Re: PA 89-25 Hardee Power Station Post Certification - Hardee to Vandolah
Transmission Line Incompleteness Response.

HARDEE POWER STATION
CERTIFICATION PA 89-25

POST CERTIFICATION INCOMPLETENESS RESPONSE

FIGURE 4

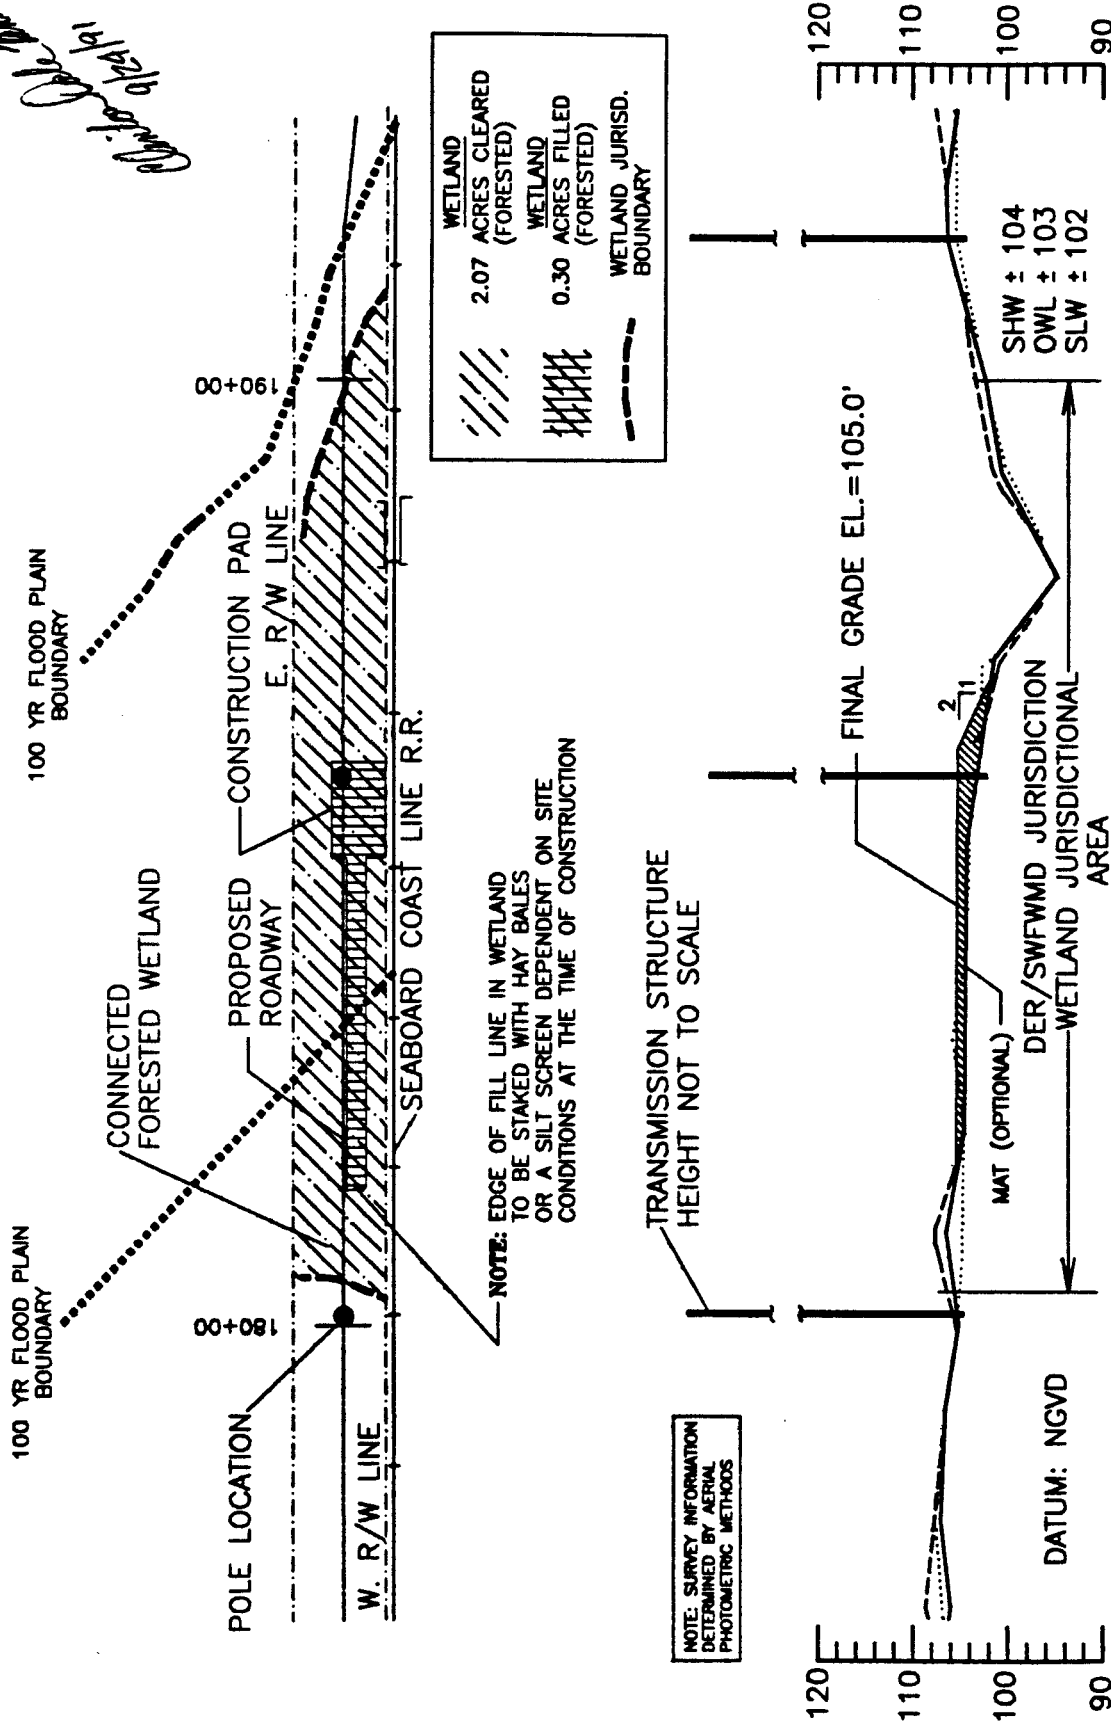
4. Figure 4 seems to indicate that a pole will be placed in the Payne Creek floodplain without a construction pad or any type of fill being placed in the wetland. If this is correct, please discuss the construction techniques that will be used and the reason (s) that fill is not required.

5. Please revise Figure 4 and 5 to show the SHWL, NWL, and SLWL for the affected wetlands.

6. Figure 4 states that a portion of the floodplain consists of pine and *Quercus virginiana* (live oak), however, the qualitative wetland description of the area lists pine and *Quercus nigra* (water oak). Please clarify what species of oak is present.

The location of the pole in the floodplain is at an elevation below normal pool in a forested floodplain and would require a large volume and acreage of fill to create the construction pad and a road to the pad. We felt this impact could be avoided in a rare case such as this by several possible methods. The method of choice is to embed this pole using a rubber tired crane assembly which will require access to this pole location.

Access to this pole is currently planned from the north across Payne Creek by the use of a temporary wooden bridge structure. This structure will be located within the ROW and will be placed at the top of bank elevation along the incised Payne Creek channel which is approximately 3 feet above normal pool. Some wooden supports will be placed within a shallow area of Payne Creek to help support the wooden bridge but will not be embedded in the sediments. The only fill involved will be these wooden supports that will be placed on the sediment interface at the bottom of the creek. The crane will access the pole area via this wooden bridge. If approval is received on the current schedule, this activity should take place in February or March, 1992 which is the middle of the dry season and will require approximately 2 weeks to complete. After that time the wooden bridge

The area represented by Figure 4 will have no fill except for a single pole and therefore no seasonal water levels were determined. We estimate the SHWL to be at the elevations of the top of bank at Payne Creek and have shown this on a revised Figure 4. Figure 5, as in the remaining figures, indicates seasonal and normal water elevations on the profile portion of the drawing.

This problem stems from multiple agency jurisdiction. The pine/live oak portion of the area is claimed by SWFWMD due to a few cinnamon ferns in the subcanopy, DER does not have the indicators necessary to claim this area, therefore this area has the correct description on the figure but is not addressed in the qualitative description nor is it included in Table 1 as DER forested area. The area within DER jurisdiction does have water oak in the canopy and subcanopy.

FIGURE 5

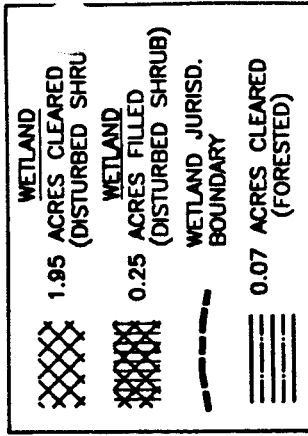
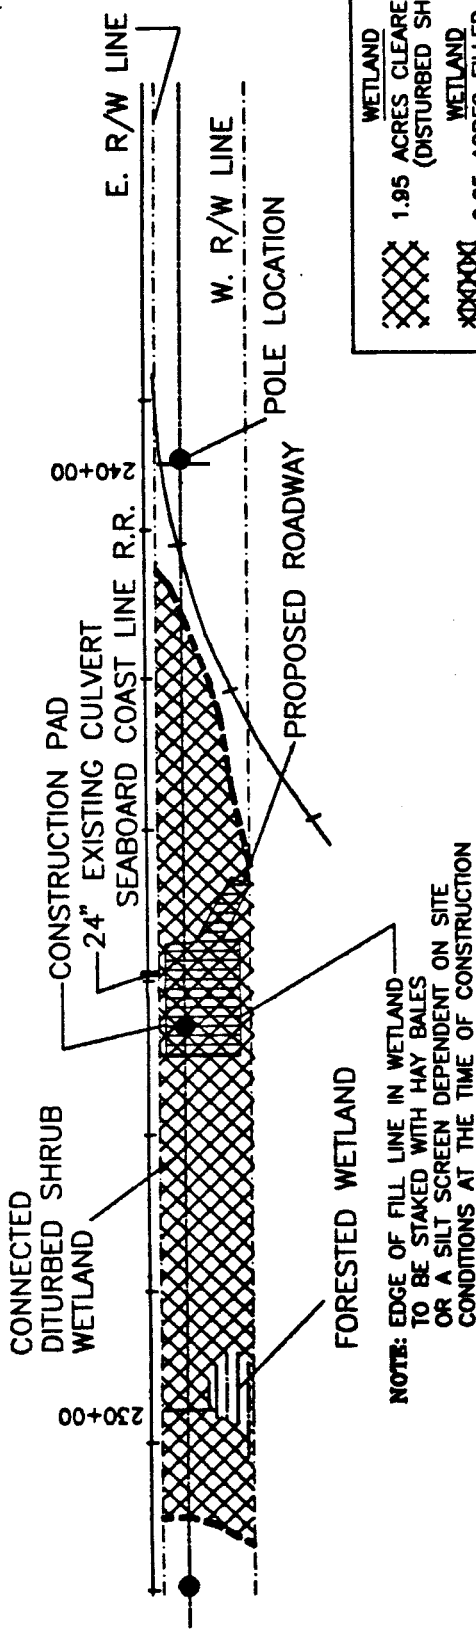
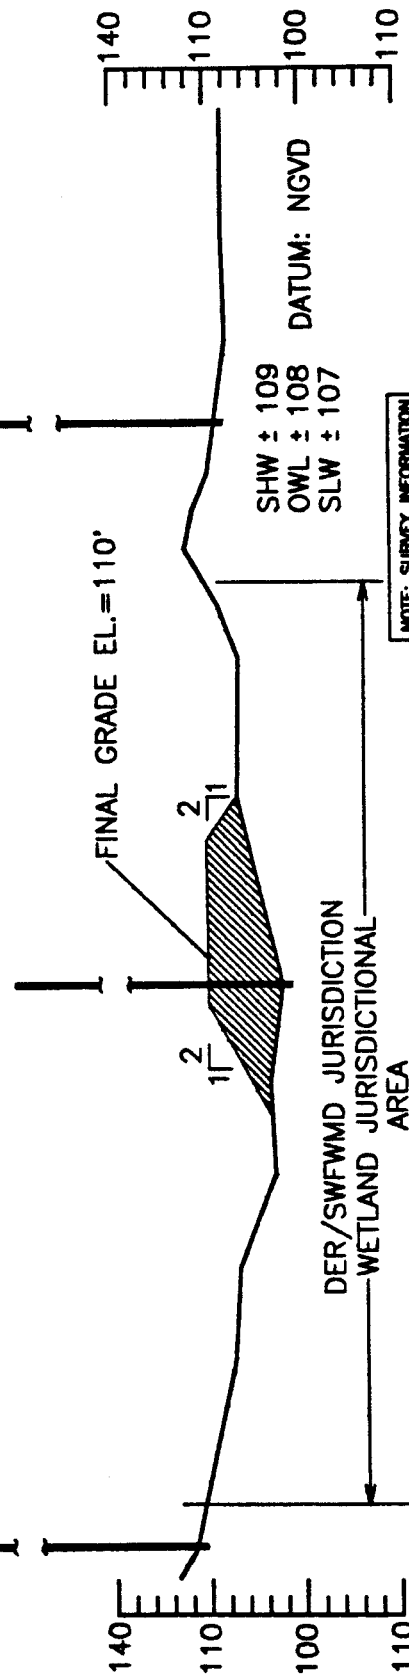
8. Please revise Figure 5 and 6 to indicate side slopes on the construction pad.

9. The wetland shown in Figure 5 is described as a seepage wetland. Please discuss any special construction techniques which will be required to stabilize the fill road and construction pad in a seepage wetland.

Please submit the letter that was faxed to Jan Burke, E.I. at the Bartow office on September 9, 1991 along with the revised plan/profile drawing for wetland "D".

We have added 2:1 side slopes to these figures. Please refer to Figure 11 which indicates the typical construction pad which has 2:1 side slopes.

As indicated in Figure 12, areas having unstable soil conditions may have a permanent fabric mat placed beneath any road fill. This procedure is planned for the Shirttail Branch area.

The letter is attached and Figure 5 has been revised to reflect the information submitted on September 9.

FIGURE 10

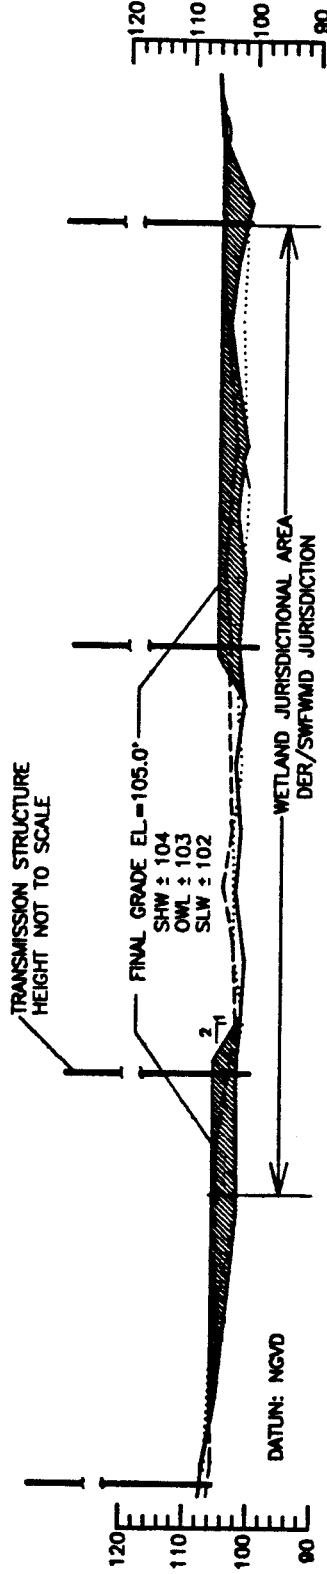
10. Please revise Figure 10 to show the location of any existing culverts in the Seaboard Coast Line RR. Are any culverts proposed for the proposed access road? If so, where? If not, why not?

11. Figure 10 and 13 are both labeled as Wetland K. Please provide a key sheet showing the spatial relationship between the two figures.

The plan view of Figure 10 utilizes the typical symbol for a RR trestle, there are no culverts in the RR grade. As indicated in the

drawing, the access road will not have any culverts.—The road will not isolate any portion of the wetland nor will it change any overland sheet flow characteristics. The wetland area adjacent to the RR and the access road should continue with the same connection and hydroperiod as currently occurs.

A key sheet is provided as Figure 1 for all wetland areas. Figures 10 and 13 both show Wetland "K" but at different scales as indicated by the scale bar. Figure 13 was created for SWFWMD to indicate compensation for fill within the 100 year floodplain.

TYPICAL ACCESS ROAD PLAN VIEW

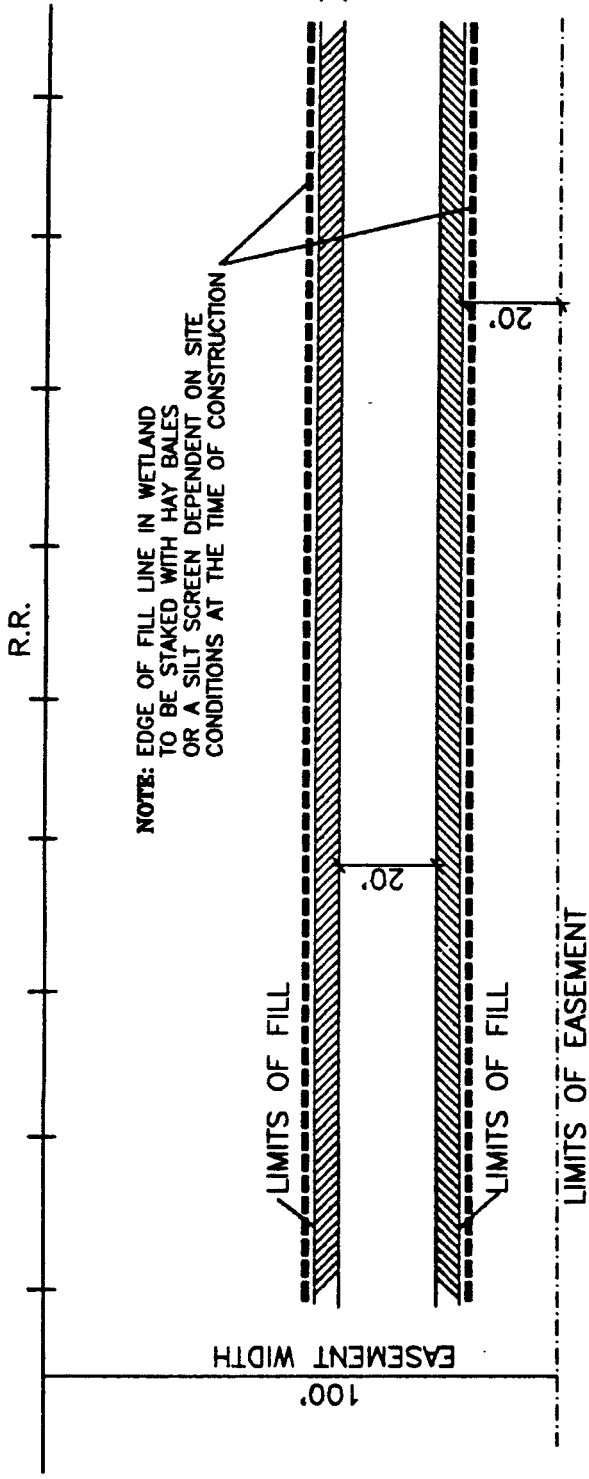
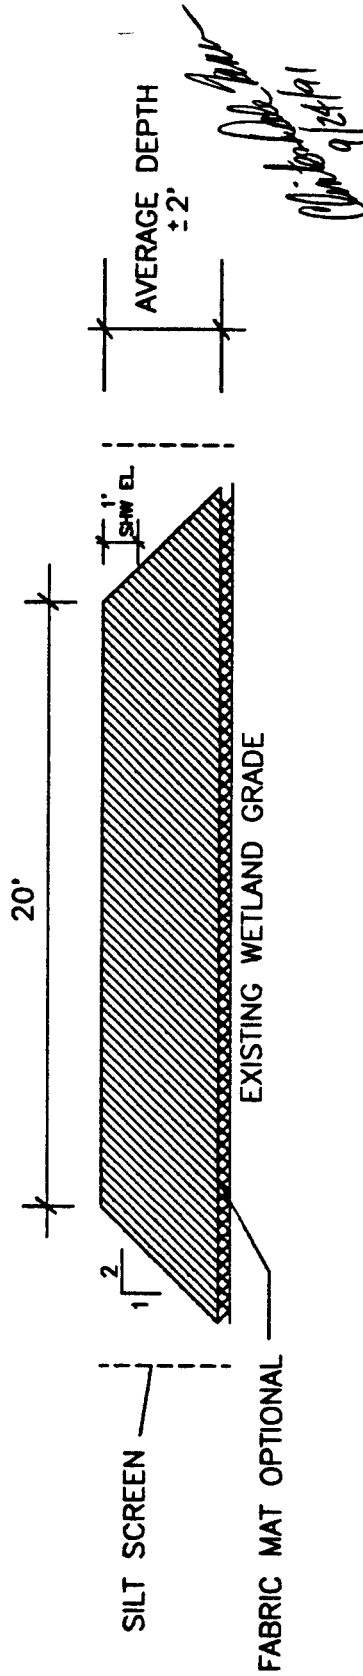
12. Figure 12 is labeled as a typical plan view and profile. Please specify of what they are typical.

This drawing is revised to indicate the typical access road that it depicts.

FIGURE 13

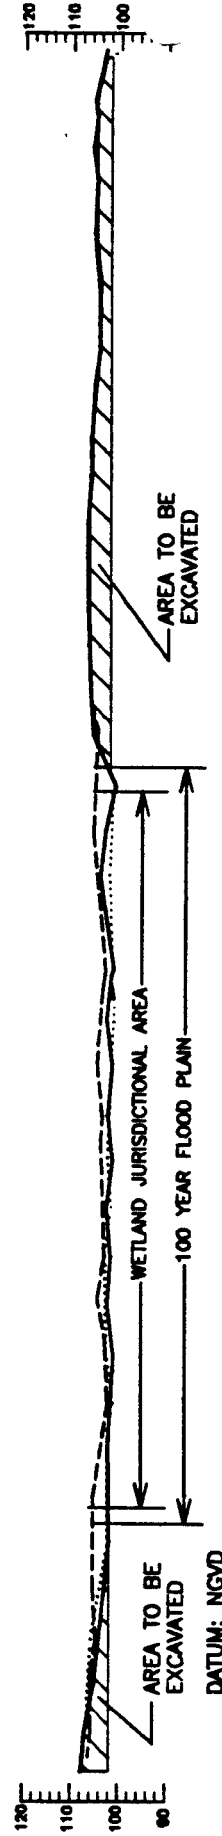
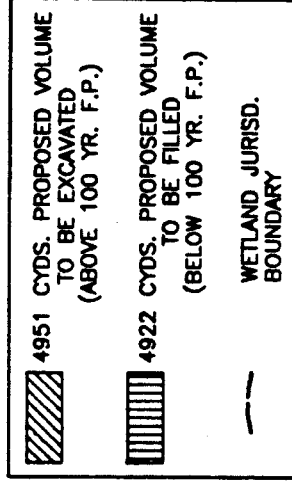
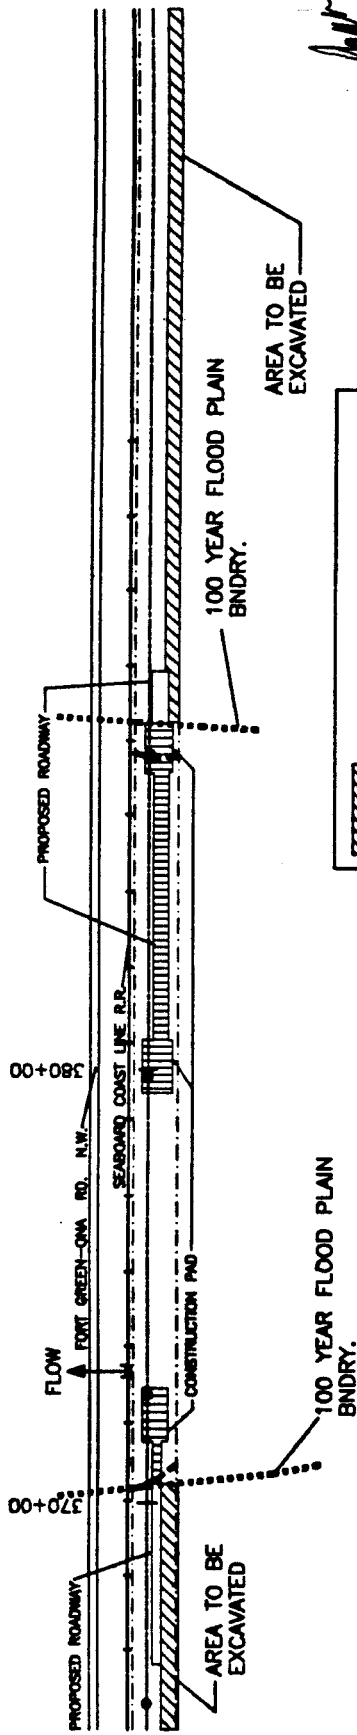
13. Please clarify the purpose and extent of the excavation shown on Figure 13.

As indicated in both the plan and profile drawings, the area to be excavated is above the 100 year floodplain, outside of the jurisdictional limits. We have been required by SWFWMD to compensate for the fill in the 100 year floodplain in this area by excavating areas above the 100 year floodplain to handle any flood waters. We do not intend for this area to be DER jurisdictional waters.
